Case # 08-10

DATE: February 6, 2008

RE: **Modifications Detail 200, Section 336 & Section 601: Trench Backfill and Pavement Replacement**

New Type E

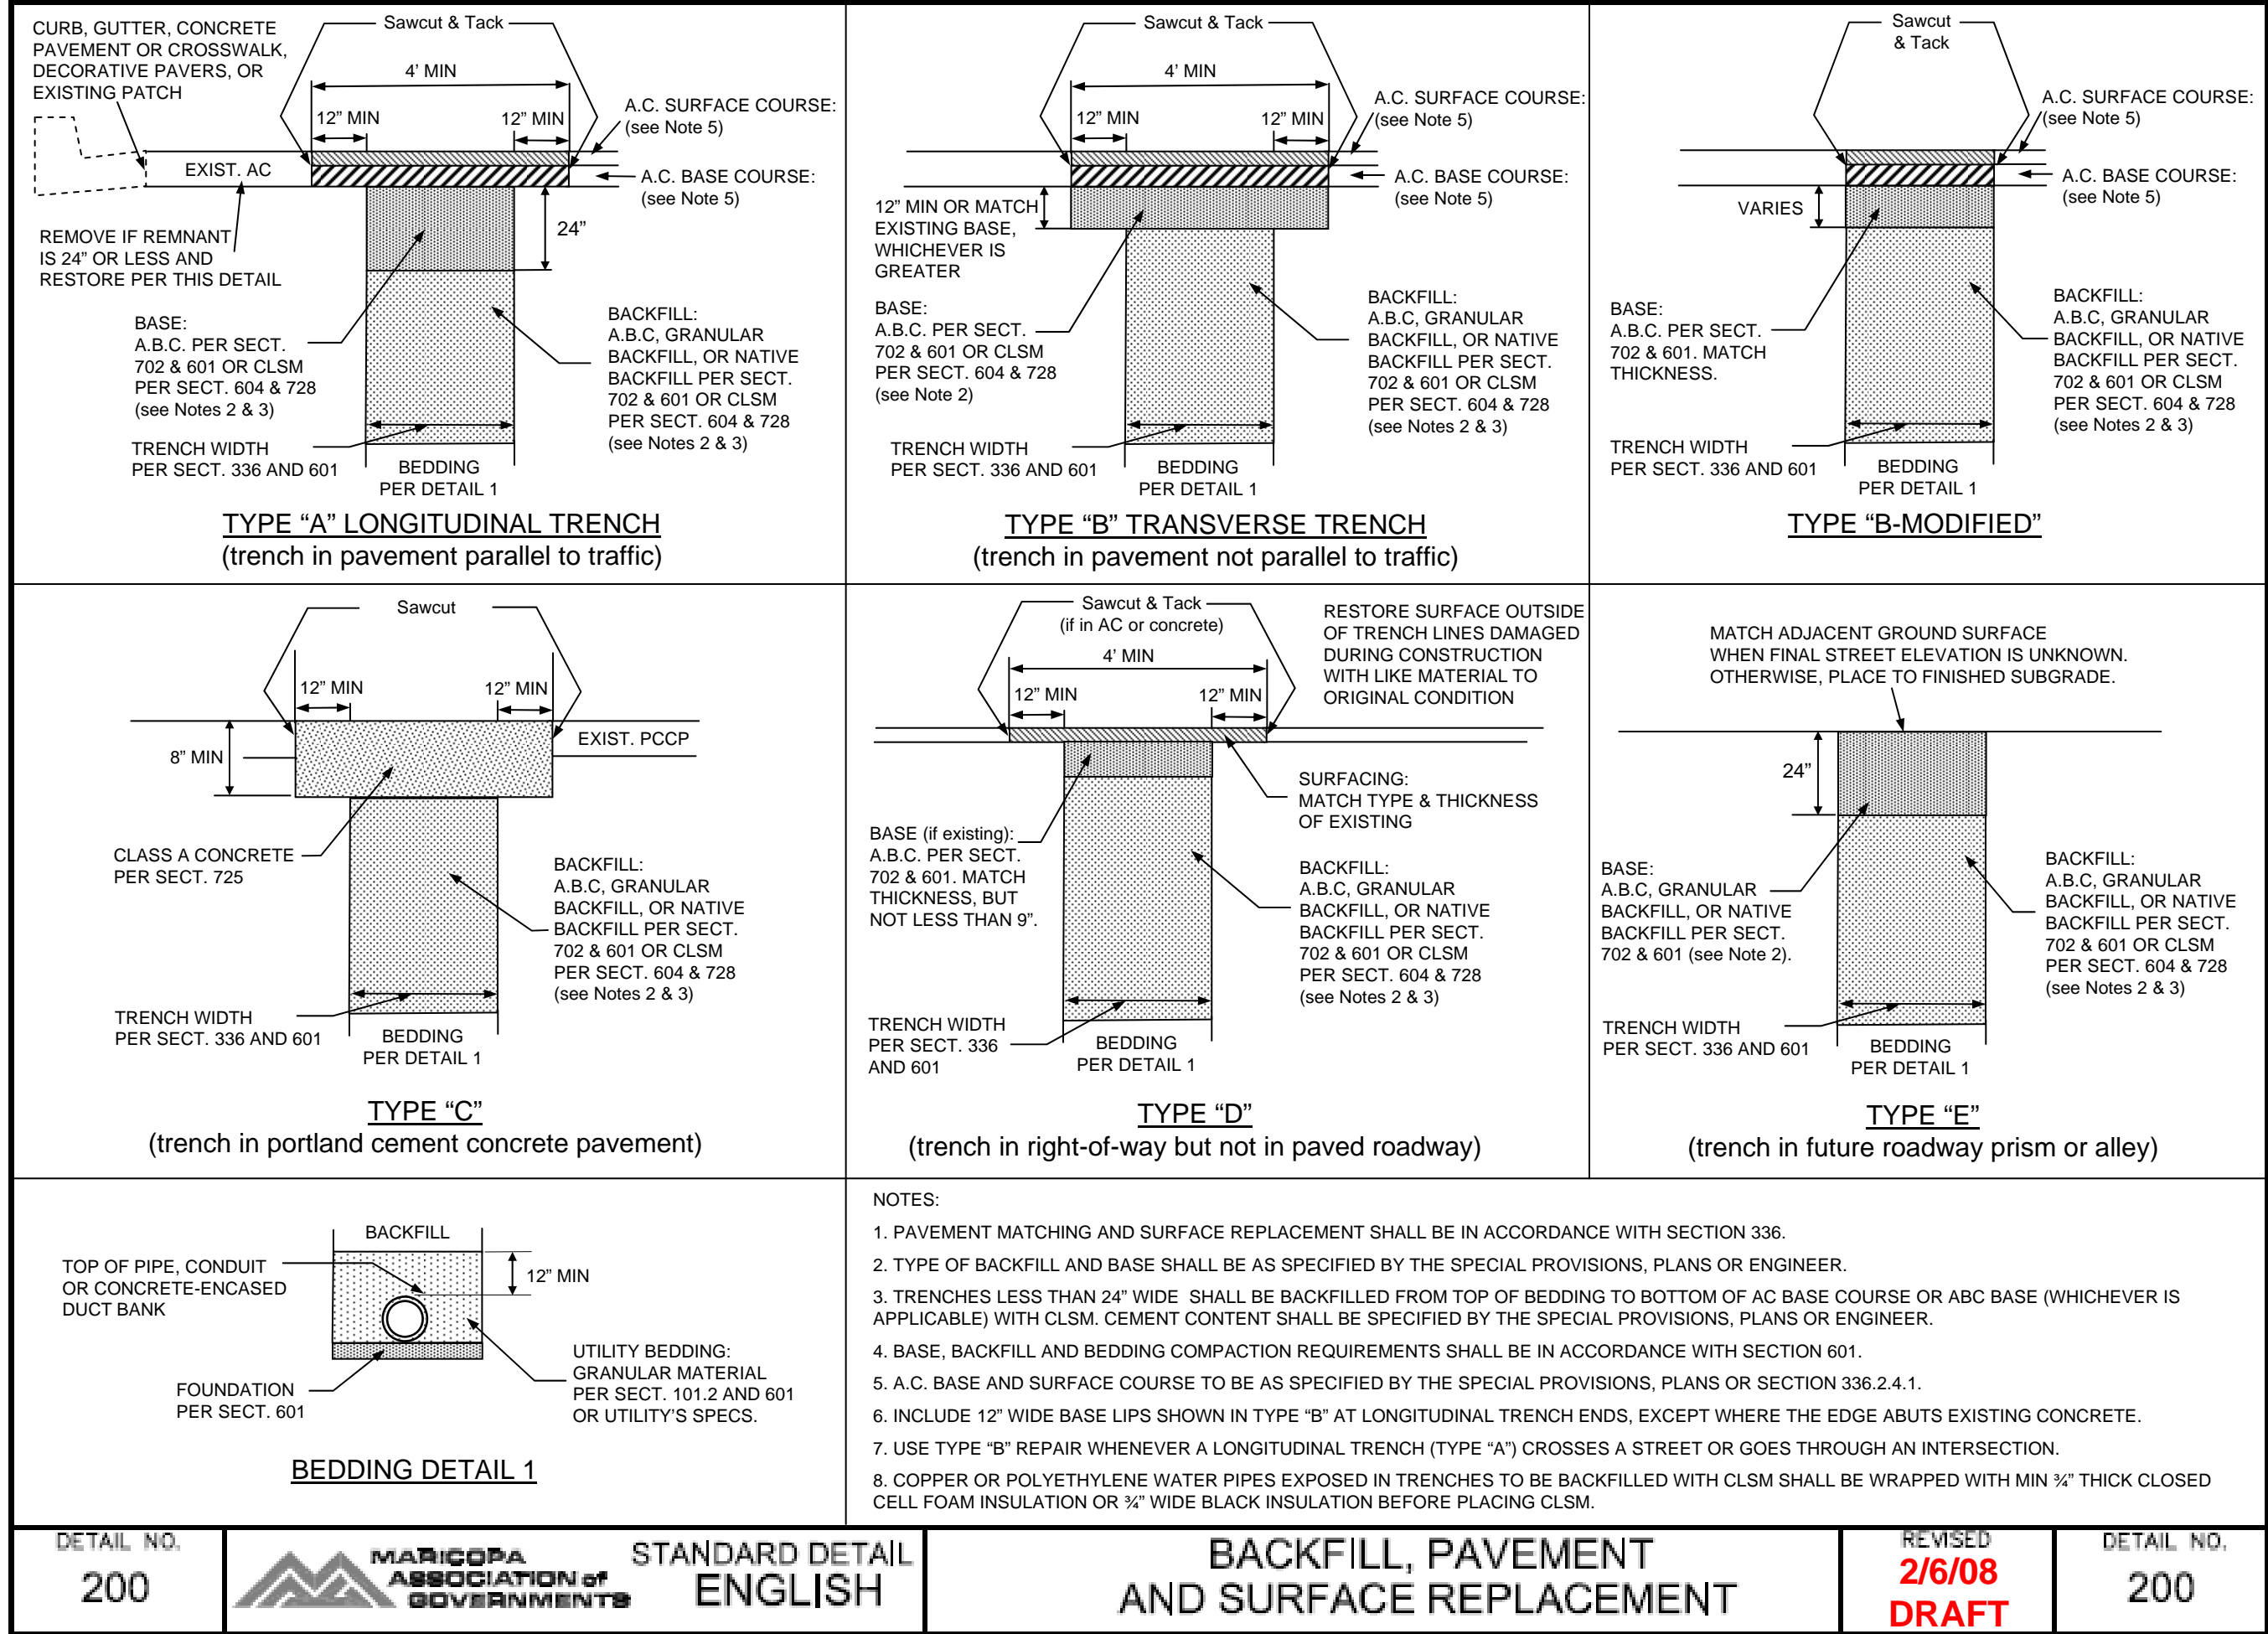
- Recommended for use in future roadway prism or alley
- Same as Type A, but with no pavement section

PAVEMENT REPLACEMENT FOR TRENCHES (T-TOP)

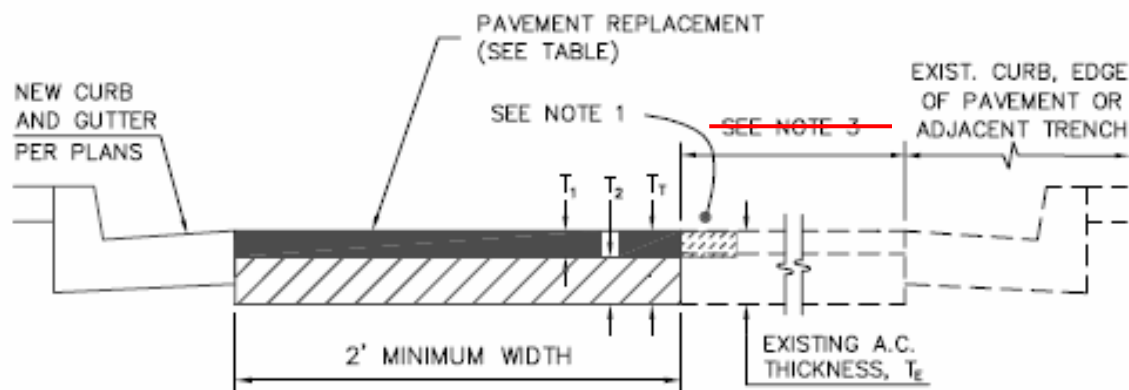
- FOR PAVEMENT 4 YEARS AND OLDER: INITIAL A.C. REMOVAL TO BE THE MINIMUM WIDTH REQUIRED FOR PROPER TRENCH COMPACTION. SAWCUT & REMOVE 12" OF A.C. MINIMUM ON EACH SIDE OF THE TRENCH FOR THE "T"-TOP AFTER THE BACKFILL MATERIAL IS PLACED. PAVEMENTS 4" AND THICKER, MILL AND REMOVE THE TOP 2" OF THE SURFACE COURSE A MINIMUM OF 6" ON EACH SIDE OF THE T-TOP PRIOR TO PLACEMENT OF THE FINAL SURFACE COURSE LIFT.

- FOR NEW AND OVERLAYED PAVEMENT LESS THAN 4 YEARS OLD AND WHEN ALLOWED UNDER THE PROVISIONS OF SCOTTSDALE REVISED CODE SECTIONS 47-79 AND ALL PAVEMENTS WITH RUBBERIZED SURFACE COURSES: INITIAL A.C. REMOVAL TO BE THE MINIMUM WIDTH REQUIRED FOR PROPER TRENCH COMPACTION. SAWCUT & REMOVE 12" OF A.C. MINIMUM ON EACH SIDE OF THE TRENCH FOR THE "T"-TOP AFTER THE BACKFILL MATERIAL IS PLACED. PAVEMENTS 4" AND THICKER, MILL AND REMOVE THE TOP 2" OF THE SURFACE COURSE EQUALLY ON BOTH SIDES OF THE TRENCH TO A MINIMUM TOTAL WIDTH OF 10 FEET. FOR PAVEMENTS LESS THAN 4" THICK SAWCUT, REMOVE AND REPLACE THE ENTIRE PAVEMENT SURFACE TO A MINIMUM TOTAL WIDTH OF 10 FEET, AS DIRECTED BY THE ENGINEER.

- FOR DEEP PAVEMENT STRUCTURES REQUIRING TWO OR MORE PAVEMENT BASE LIFTS: INITIAL A.C. REMOVAL TO BE THE MINIMUM WIDTH REQUIRED FOR PROPER TRENCH COMPACTION. SAWCUT, REMOVE AND REPLACE A.C. ON BOTH SIDES OF THE TRENCH AS NECESSARY TO ACCOMMODATE A RIDE ON TYPE VIBRATORY ROLLER COMPACTOR FOR PLACEMENT OF THE A.C. BASE COURSE LIFTS, MATCH EXISTING A.C. DEPTH. MILL AND REMOVE THE TOP 2" OF THE SURFACE COURSE EQUALLY ON BOTH SIDES OF THE TRENCH TO A MINIMUM TOTAL WIDTH OF 10 FEET.

- ~~ASPHALT CONCRETE SHALL BE IN ACCORDANCE WITH THE REQUIREMENTS OF MAG SECTION 321.~~
- ~~IF PAVEMENT REMNANT IS LESS THAN 36", REMOVE AND REPLACE PAVEMENT AS PER THIS DETAIL.~~
